Mu2e Accelerator Design Review Recommendations

Mu2e Accelerator Management Team

Mu2e Director's Review

20 April 2016

Accelerator fault matrix

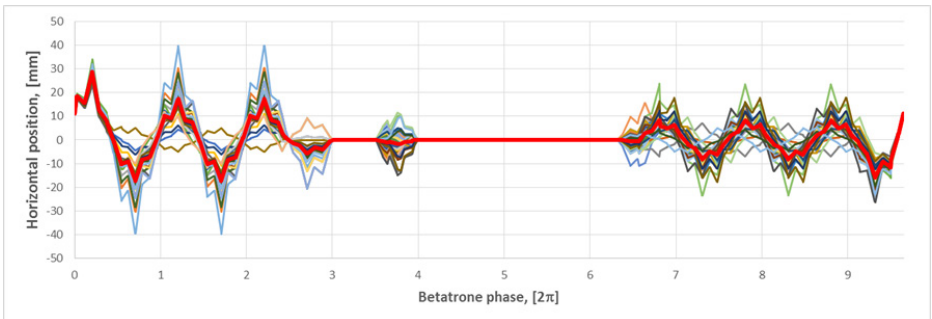
A more comprehensive analysis of beam faults and their detection needs to be done, with a focus on building a realistic fault matrix.

- Preliminary FMEA has been performed using projections from the MI downtime data
- Comprehensive fault matrix has been built
- Analysis is published in the Mu2e-docdb-7301

B8Q24-113
2100 A

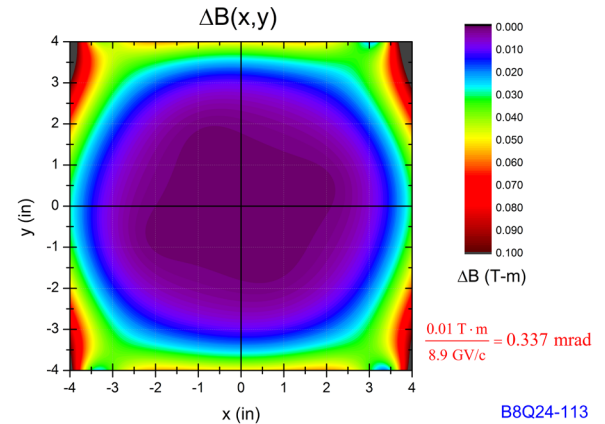
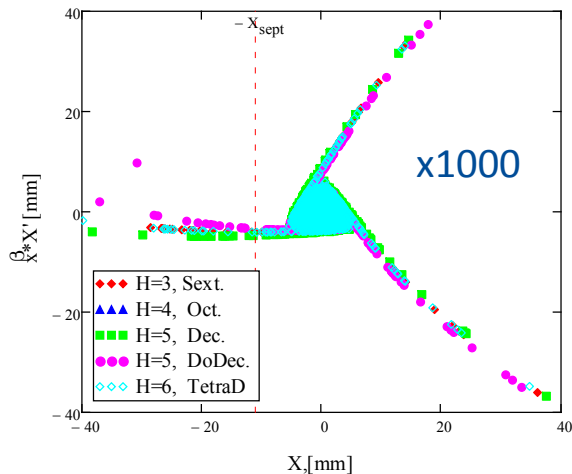
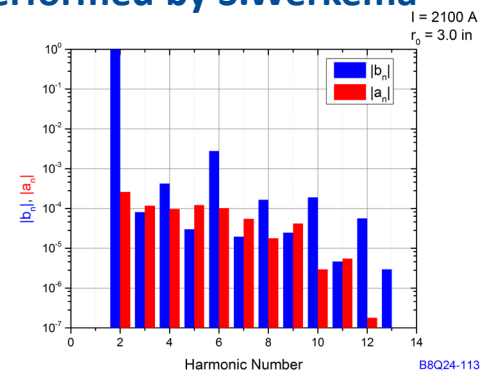
The impact of poor field quality needs to be quantified.

The large aperture 8Q24 quad will be used in place of Q205 in the Delivery Ring

Magnet measurement data analysis performed by S.Werkema

Effect of parasitic harmonics: Distortions in the extracted beam phase space start to appear when harmonics are 1000 larger than measured

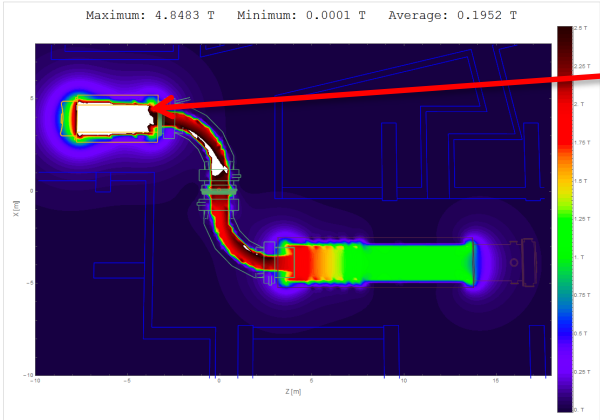
1. Instrumentation: The concern over the as-yet unproven vacuum window design is appropriate, but not a major issue for meeting project technical or schedule demands. The expectation is that a prototype will be ready for testing within a few weeks. There is adequate float in the Mu2e schedule should problems be discovered and the g-2 project needs a solution for this same design much sooner than Mu2e. The risk associated with deleterious effects on instrumentation of the production solenoid magnetic field is appropriately recognized and the need to resolve the concern is understood.

- A prototype ion chamber using the new vacuum window design was built and passed a two-stage vacuum certification test.
- Beam studies are planned to test profile monitors in the production solenoid magnetic field (see next slide).

PreTarget MW:
1.2Kg magnetic field

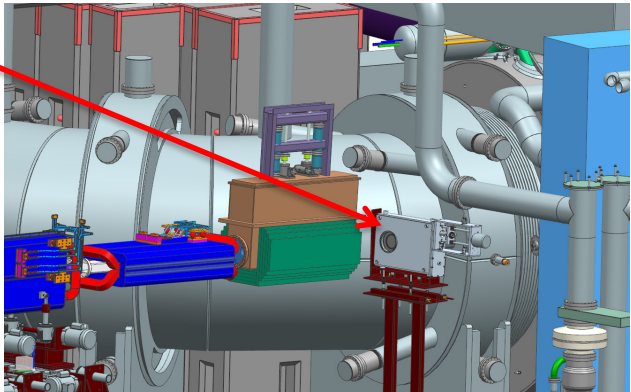
- 1. Pursue a location and test the remaining questions about the performance of the profile monitors in the fringe field of the production solenoid.

Various options were explored for testing a profile monitor in a 1.2Kg magnetic field. There are planned studies using MICE solenoid in the MTA beam line. We have added resources to the design scope in BCR029 to extend the MTA studies to include putting a multiwire in the beamline in the field of their solenoid. Instrumentation will locate and modify a spare multiwire for this test.

HRS Thermal Fluid Simulation
Erik Voirin, Zhijing Tang
Mu2e Doc. 6409
Dec 2015

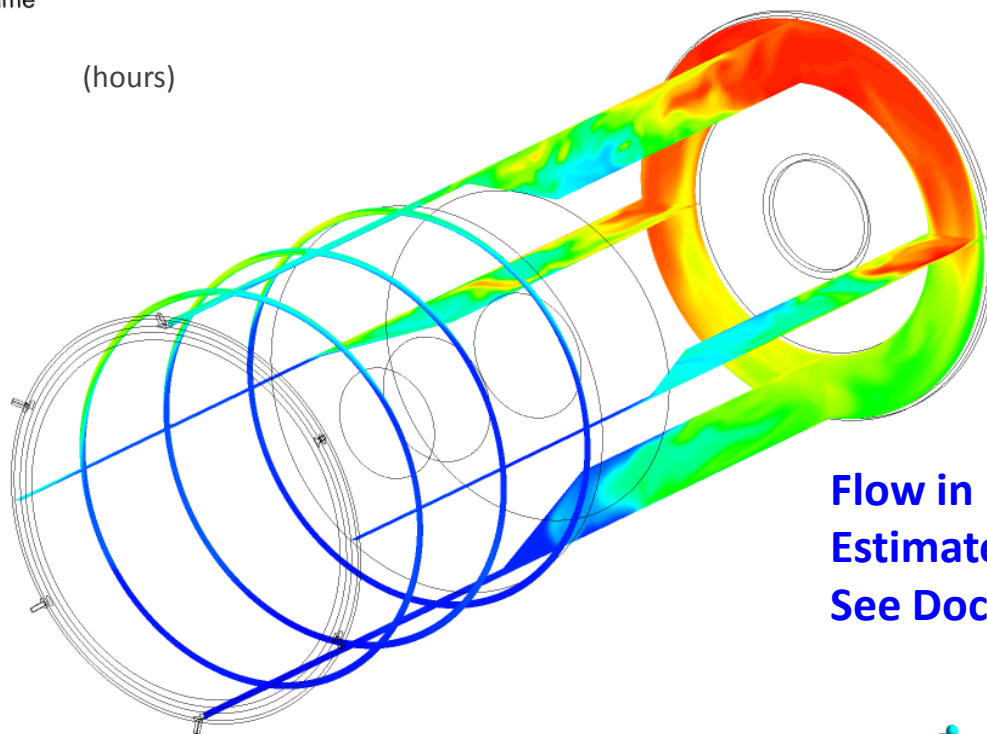
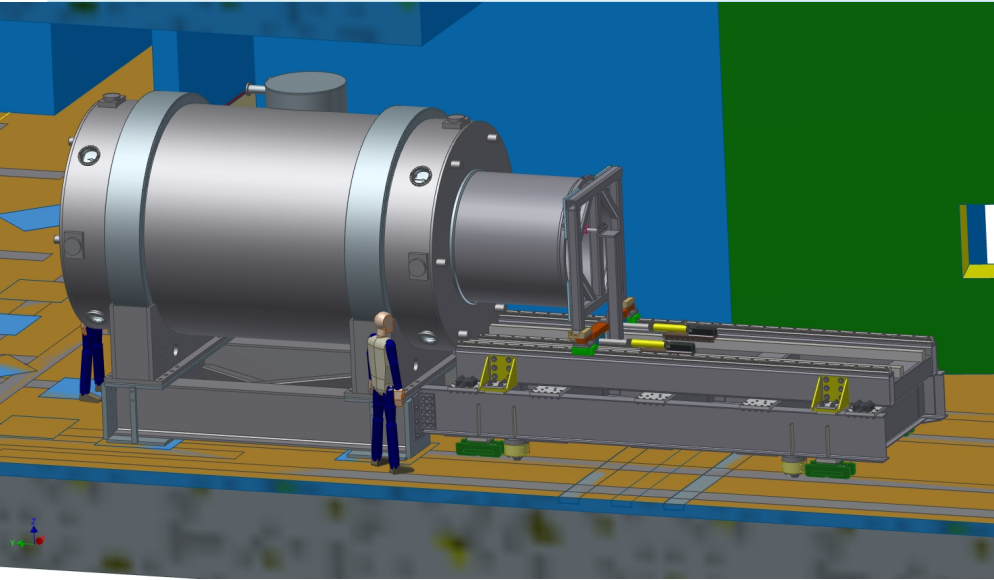
1. HRS stagnant water next to the welds in the maximum radiation area may accelerate corrosion in the welded areas, leading to a leak into the vacuum space. This risk needs to be evaluated.

A fluid simulation was performed which indicates the maximum dwell time of water in the HRS is only a few hours under very conservative assumptions so the level of stagnancy is minimum (Mu2e Document 6409). Fermilab welding experts were also consulted on quality control of the welding. The conclusion was given the thickness of the stainless steel tank, quality control of welds and water flow that a leak due to corrosion should not occur.

**Flow in Bronze Gaps Also
Estimated with Purge Time of ~ 8hrs
See Document for details**

PS Inner Bore Subject to HRS Load
Ang Lee, Mu2e Doc. 7288, April 2016

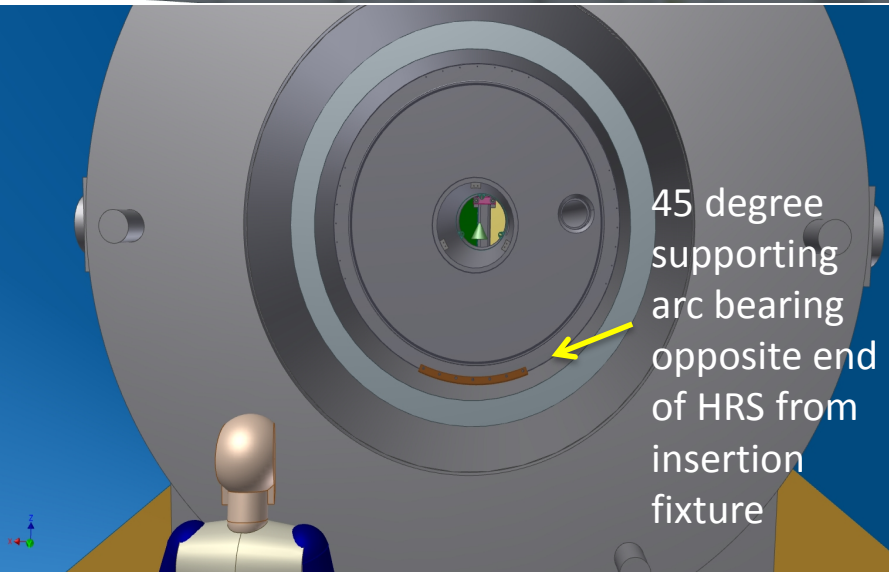
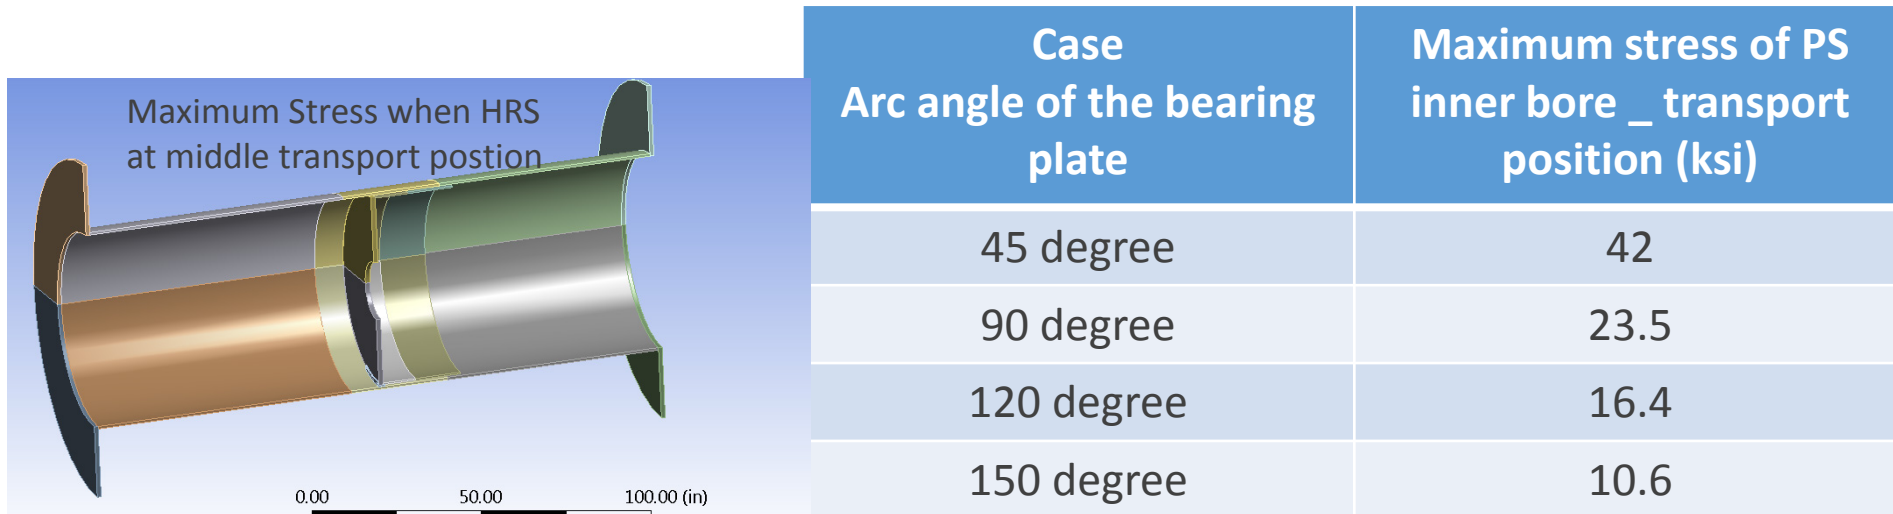
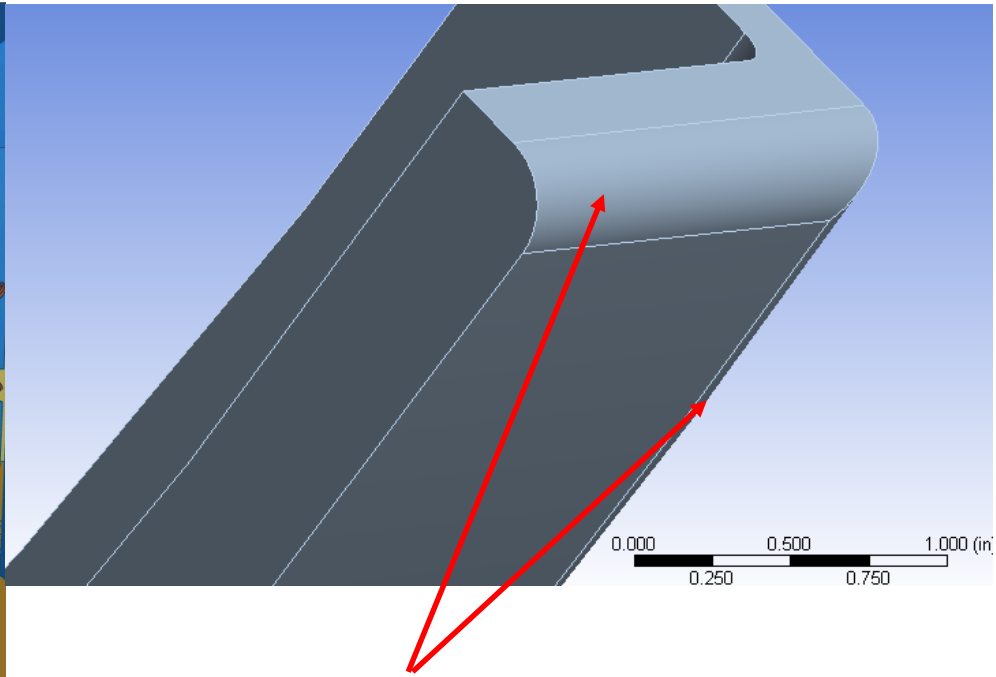
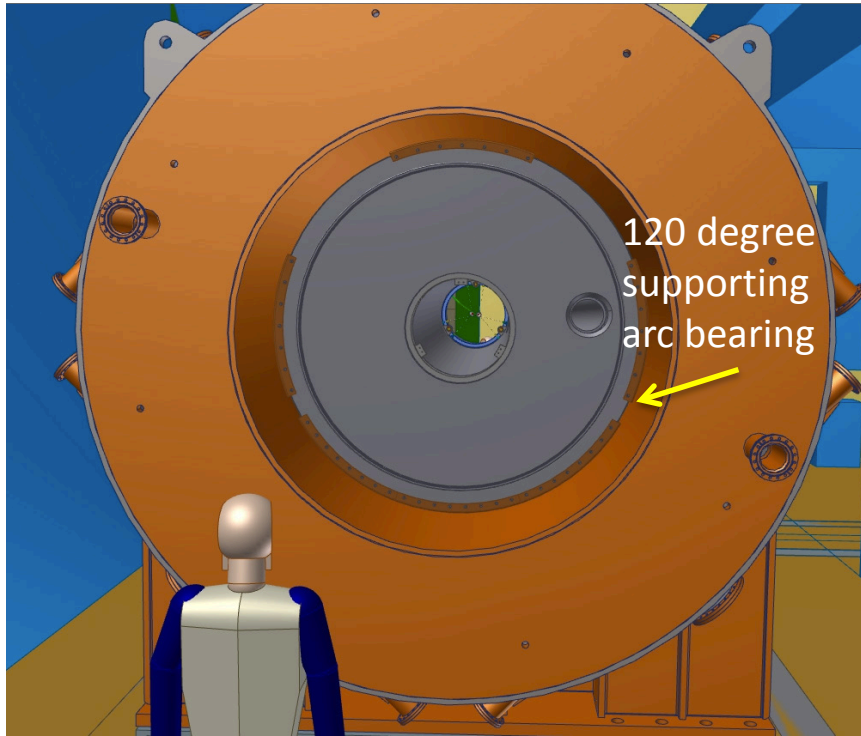
1. The solenoid design needs to be reviewed to assure it can support the weight of the HRS during installation.

The stress due to the weight of the HRS on the PS bore tube has been calculated to exceed the allowable stress by the PS contractor (General Atomics). The high stress in current models is under the arc bearing attached to the HRS. Fermilab has performed an independent finite element analysis with a modified arc being. Increasing the size of the arc bearing results in an allowable stress (Mu2e Document 7288). This design change has been sent to GA for their re-analysis.

After GA analysis, meetings with Tom Page, Larry Bartoszek, and Ang Lee resulted in a new analysis with a modified design for HRS arc bearing

- 1) It seems that the increase the arc length of the bearing plate can effectively reduce the stress of the PS inner bore. GA (ref_1) uses **20 ksi as the allowable stress** for the inner bore.
- 2) The middle transport position is the worst case.
- 3) The bearing plate has a high stress concentration (singularity) at its edge due to 90 degree sharp angle. If a corner radii or round edge is given, the stress can be reduced significantly.

45 -> 120 degree
42 ksi -> 16 ksi

Independent Control of Delivery Ring LLRF

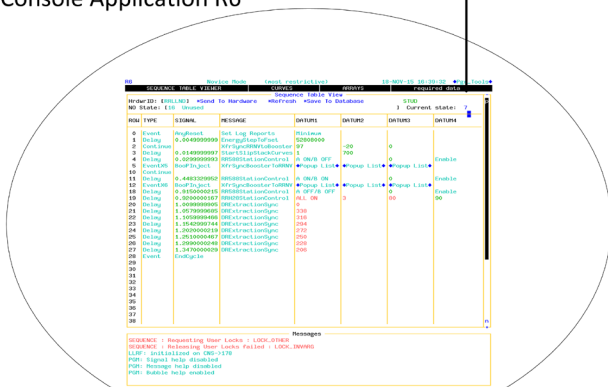
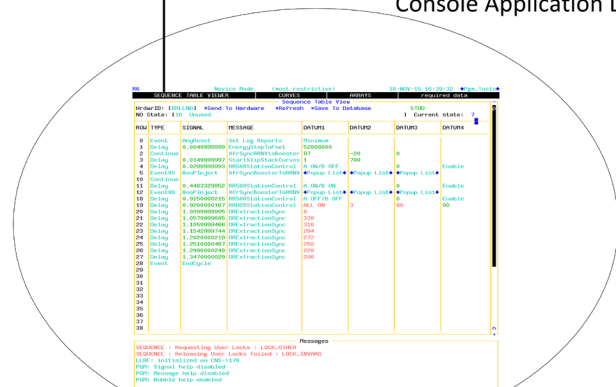
- Recommendation 2c : The risk that the final system design will not have the flexibility to implement the accelerator beam studies desired. Recommendations are found elsewhere in this reviewers' response.
- Response : The Accelerator Division Low Level RF Department has investigated this and a formal response will be posted in the document database. The formal response is located in Mu2e-doc-7176
- Status : Closed

Slide from Mu2e-doc-7176

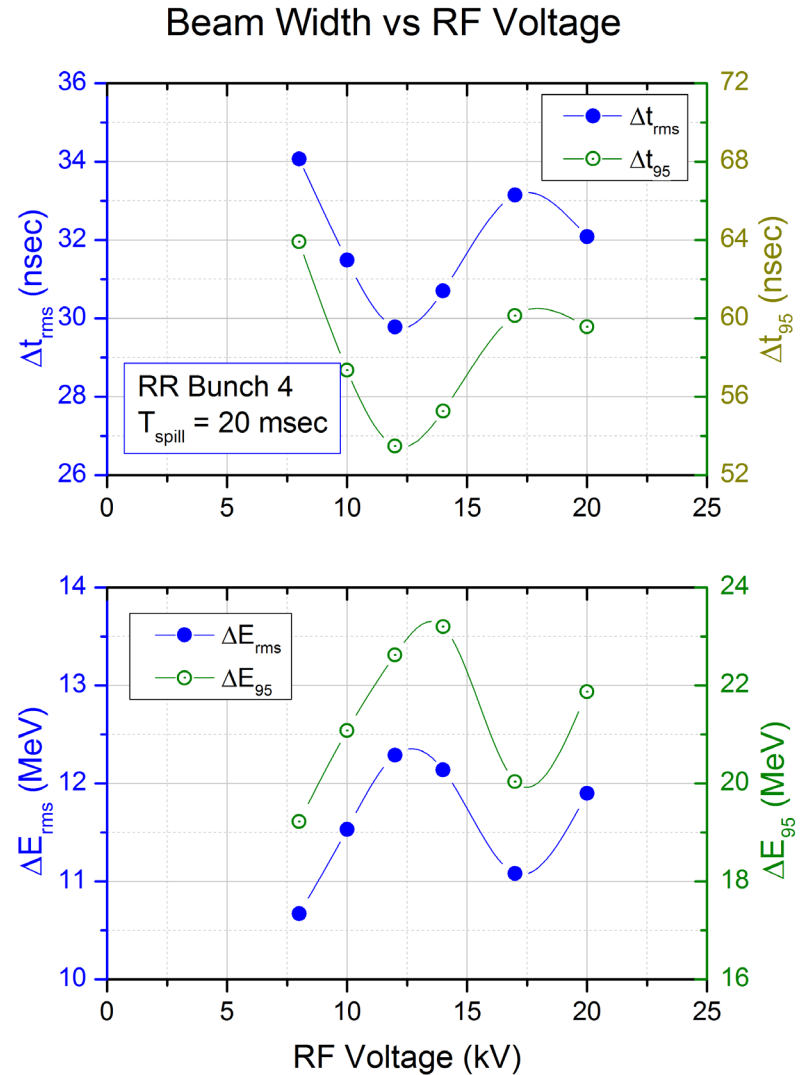
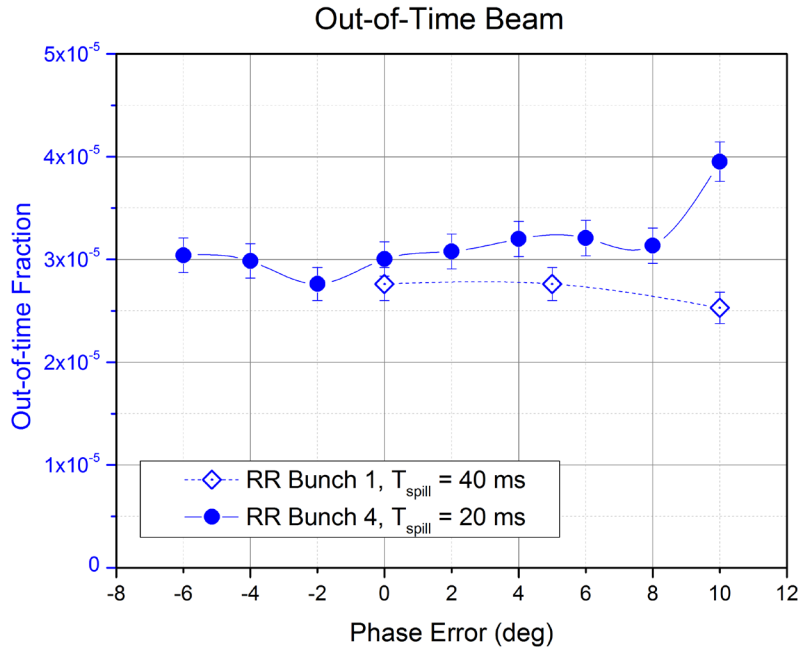
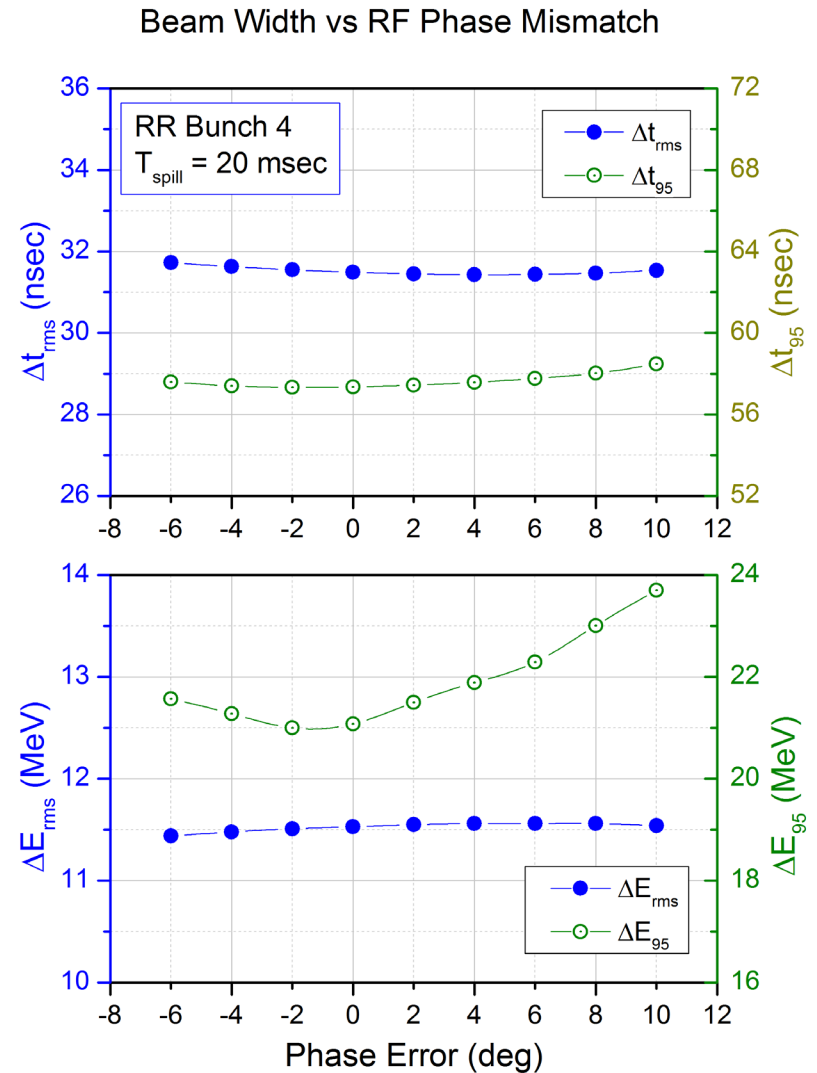
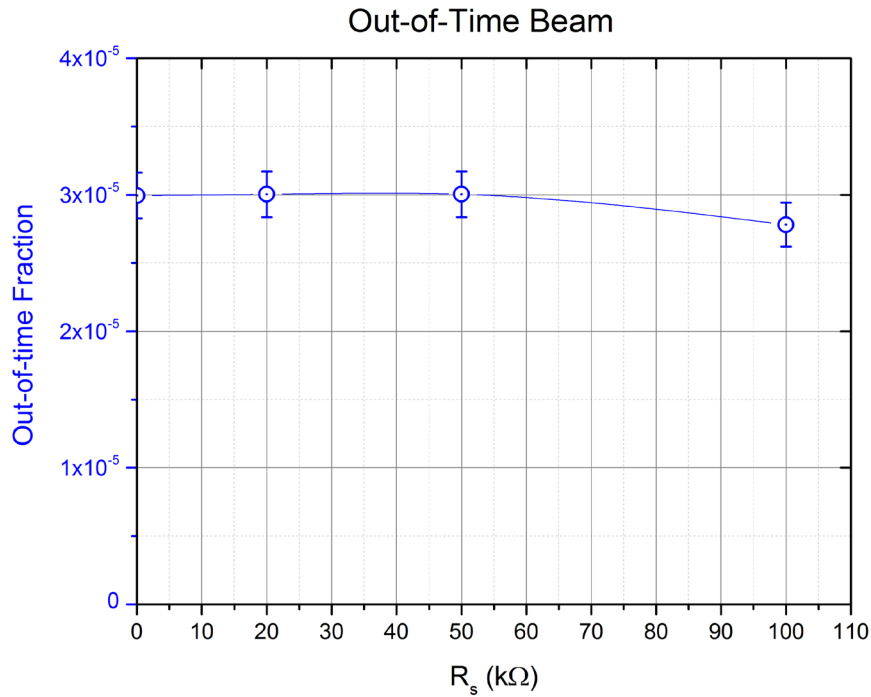
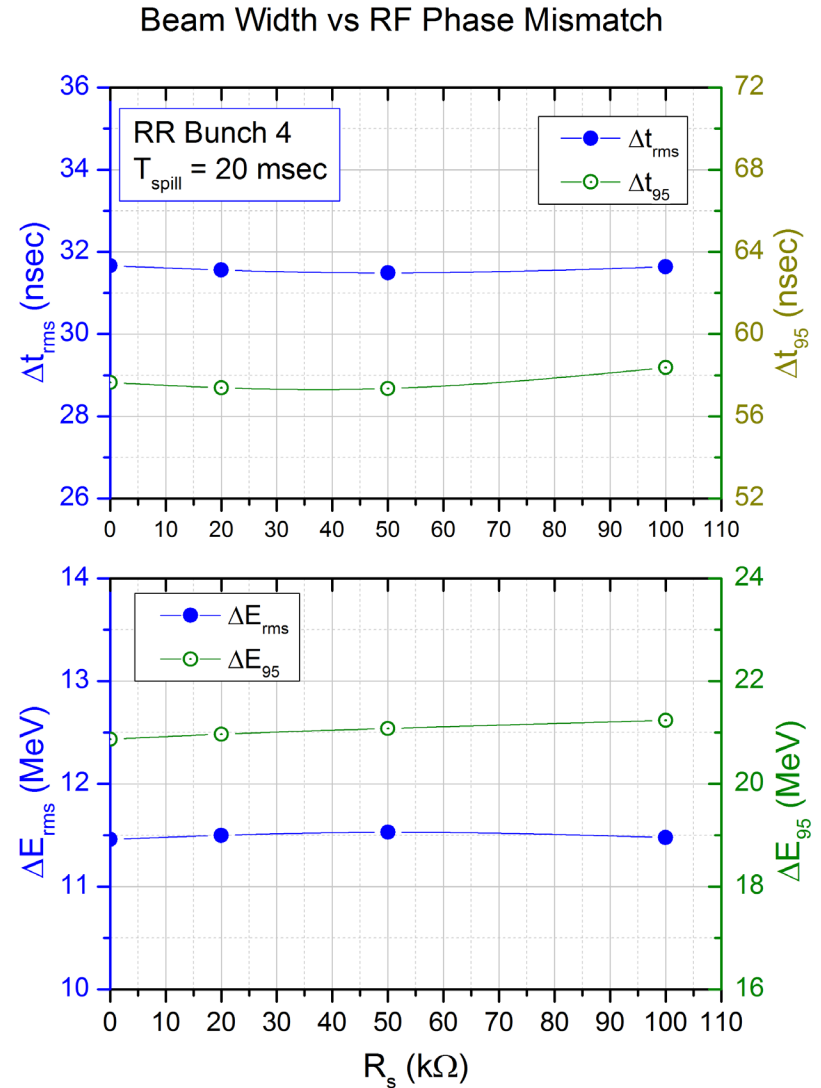
- Recommendation 1b : Additional simulations should be performed to include the phase and energy variations. Simulations using the Recycler Ring model should be performed with the inclusion of the cavity impedances. The effects of the Higher-Order Modes of the cavities should be investigated. The documentation of the simulations needs to be updated for the CD-3c review.
- Response : Steve Werkema has completed the ESME simulations. A formal document will be ready for the DOE CD-3c review.
- Status : In Progress

- Nominal $V_{rf} = 10$ kV
- Extinction improves with increasing voltage and does not degrade when voltage is decreased to 8 kV

- Phase mismatch of less than 10° does not appreciably degrade extinction.
- Beam energy and time widths are not appreciably affected by mismatch of less than 10°

Performance does not depend on impedance less than 100 k Ω
